Re-Bid Addendum No. 2

Project : **DNR- 230014.03**

FY23-24 Buck Creek State Park – New Nature Center

To All Bidders: This Addendum updates the Drawings and Project Manual designated “**RE-BID SET**” dated: **February 6, 2024**. Content within this Addendum shall become part of the Contract Documents.

ELECTRICAL SCHEDULES & RISER DIAGRAM E-4-0

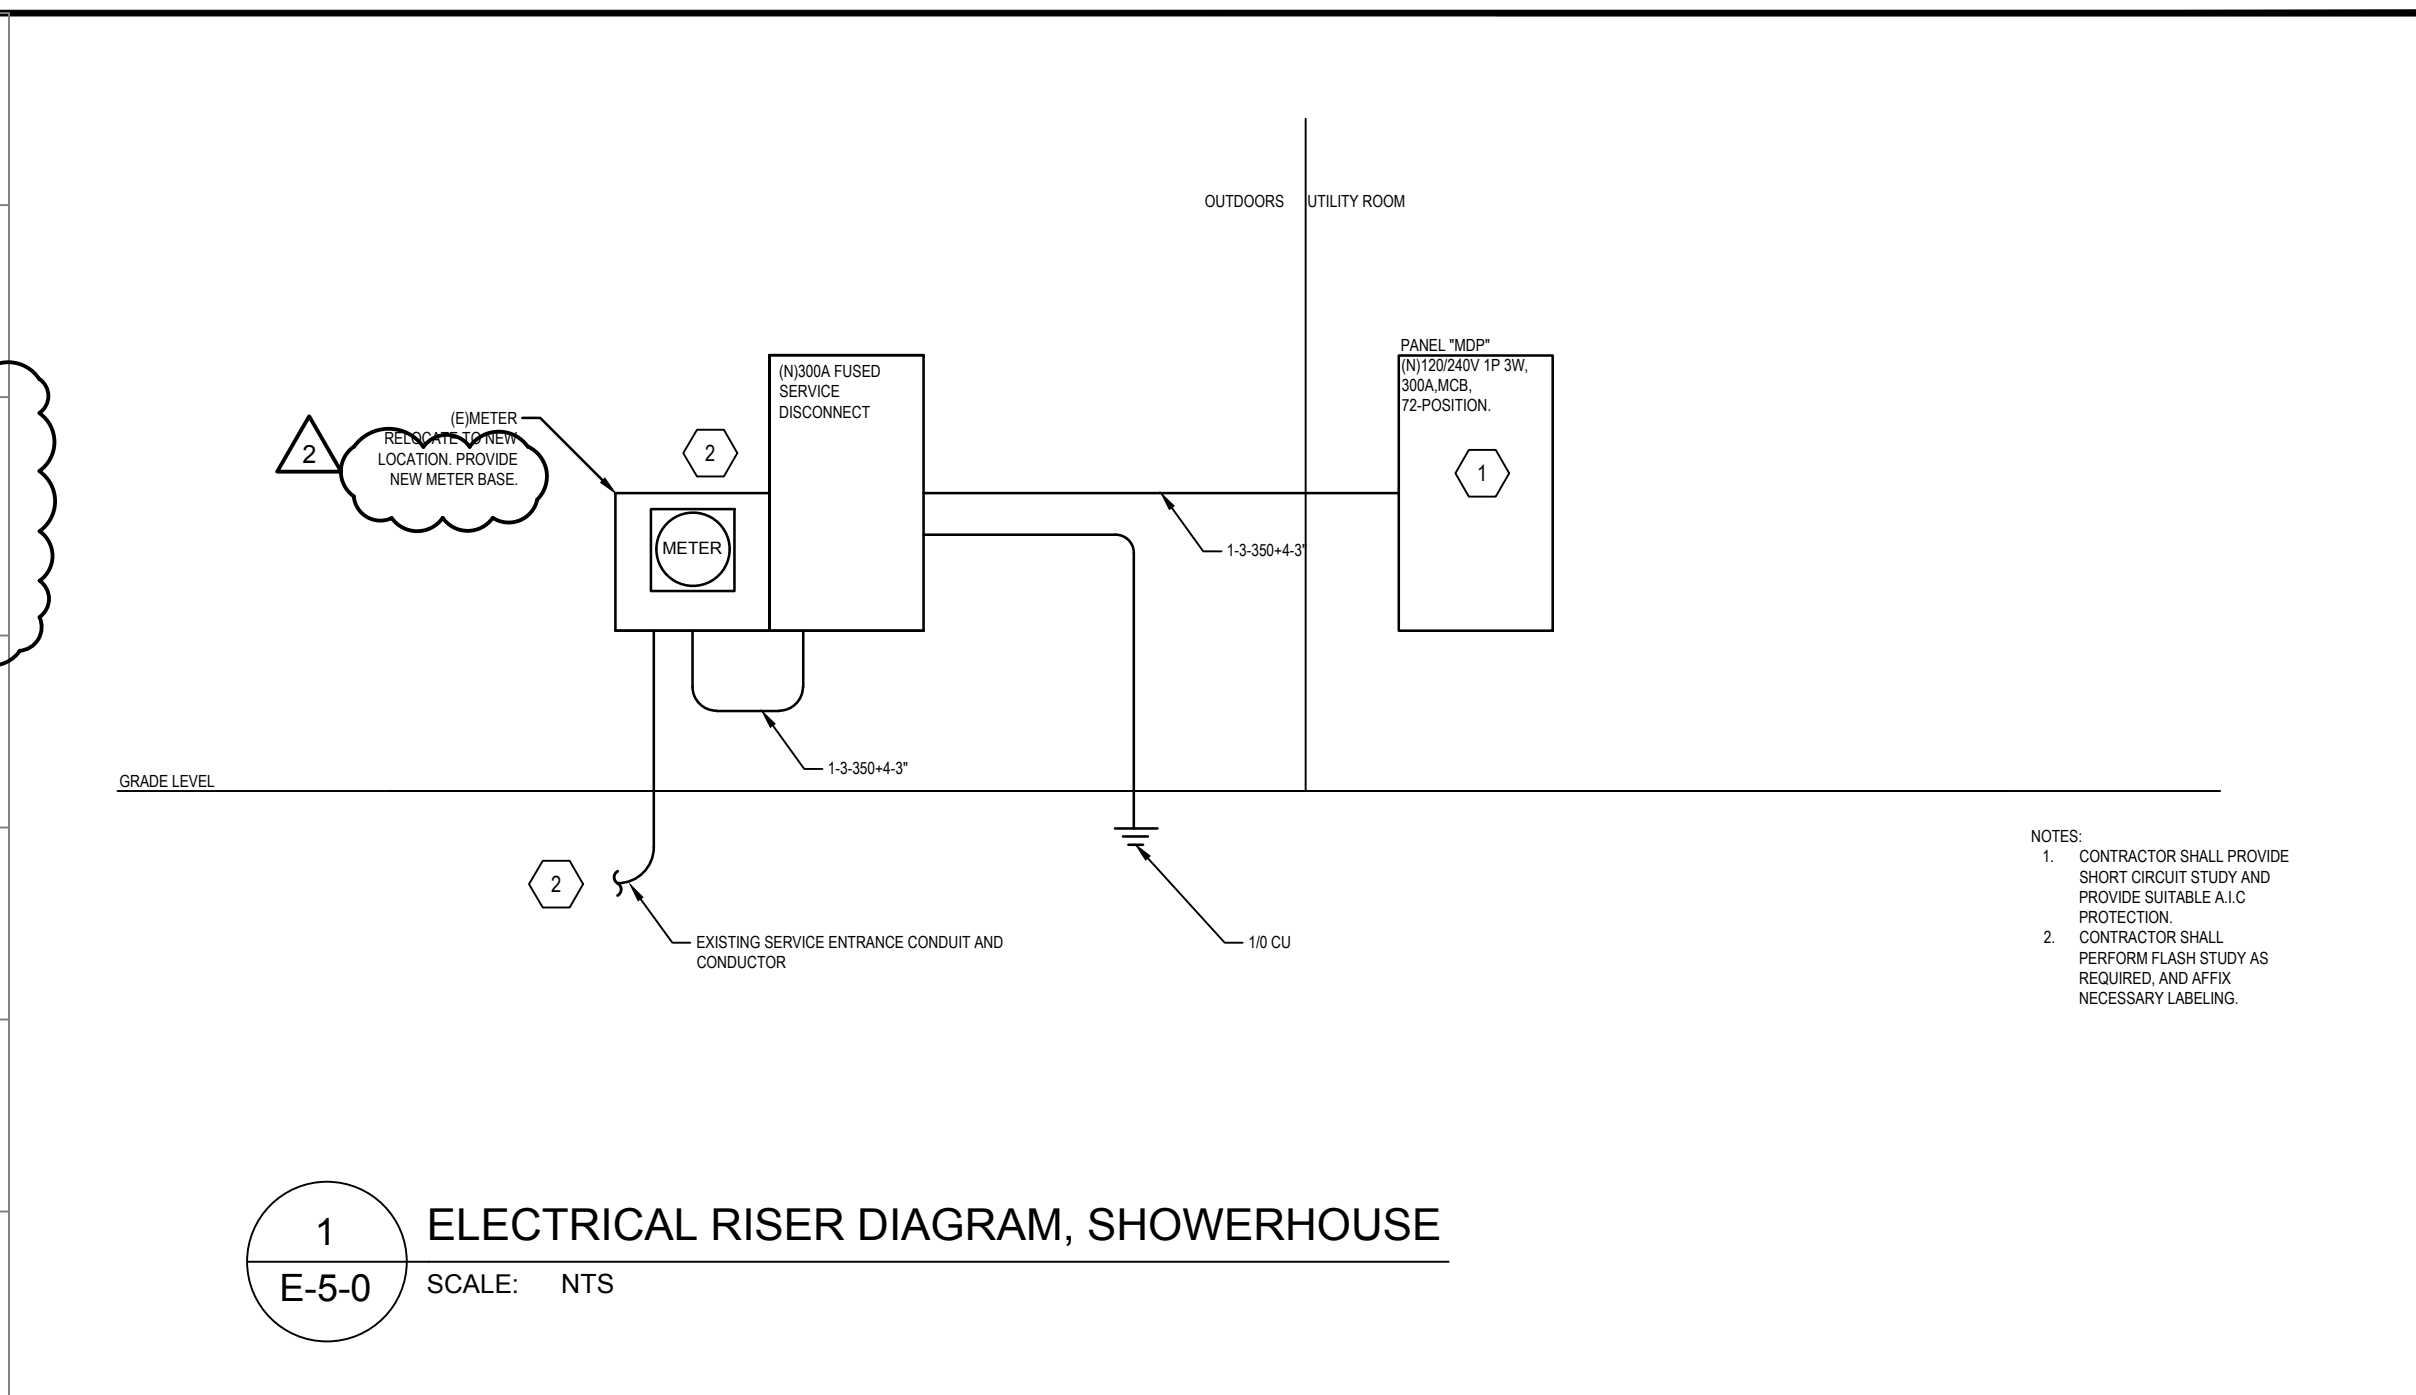
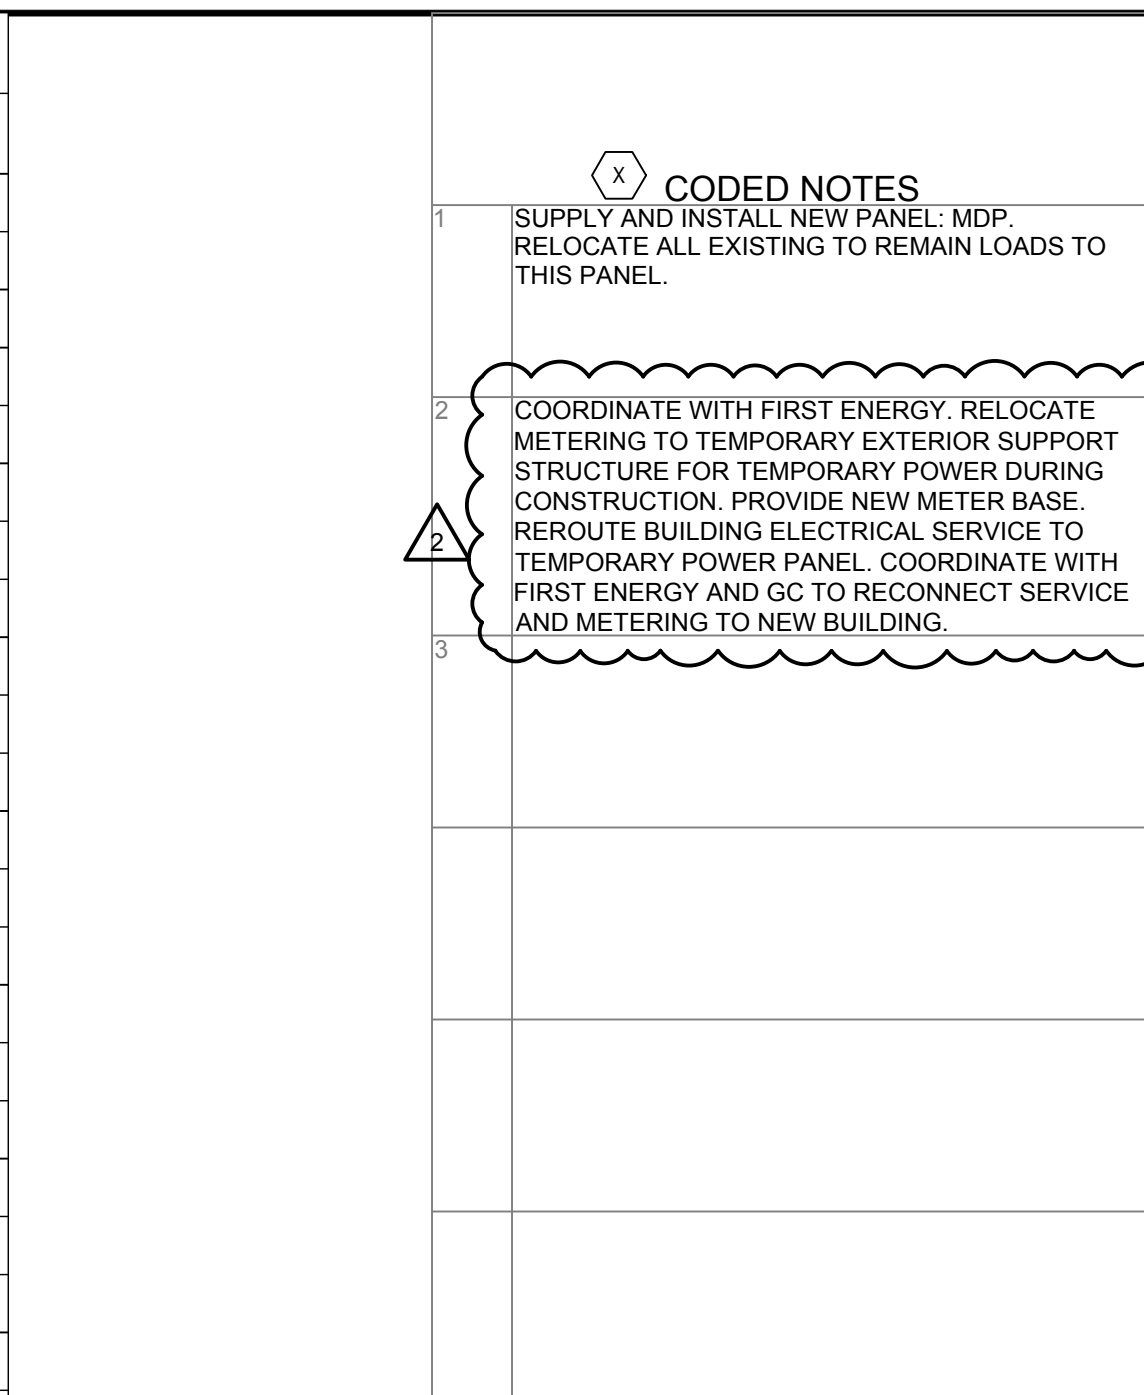
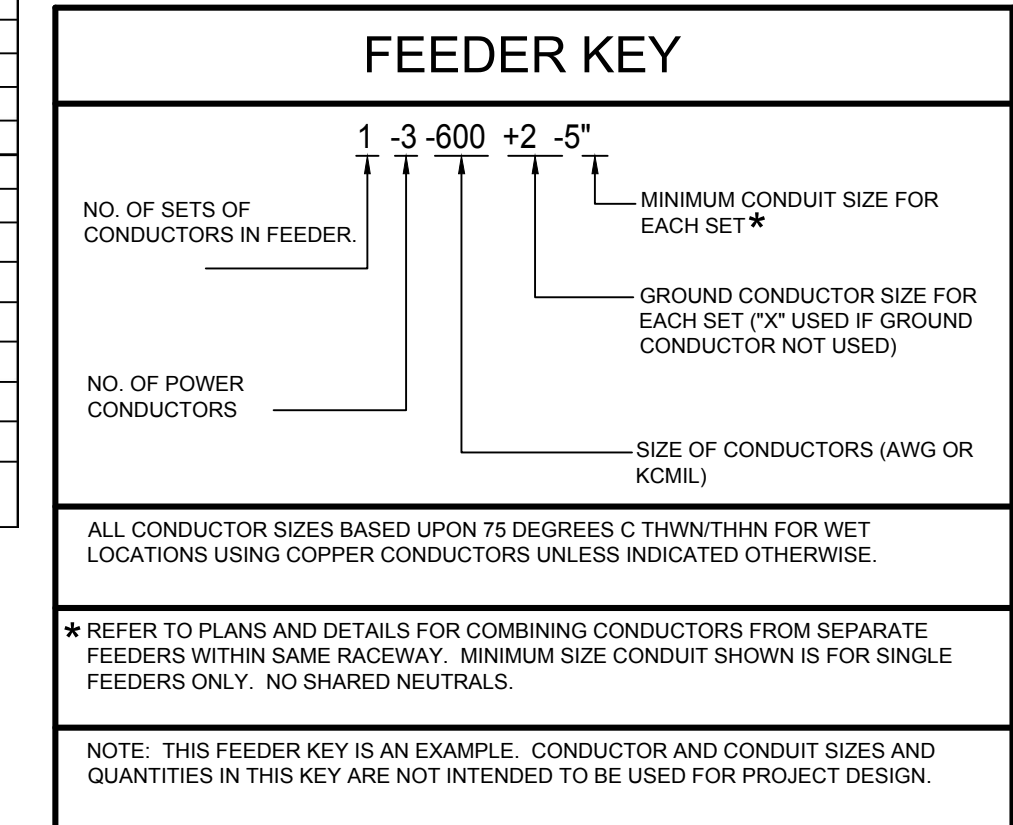
Re-Bid ADD2.6: CLARIFICATION to Drawing E-4-0 -- ELECTRICAL SCHEDULES & RISER DIAGRAM:

1) Removed 24V control power transformer circuit from new panel MDP.

2) Revise power riser coded note 2 to clarify scope for temporary power, and to include addition of new meter base.
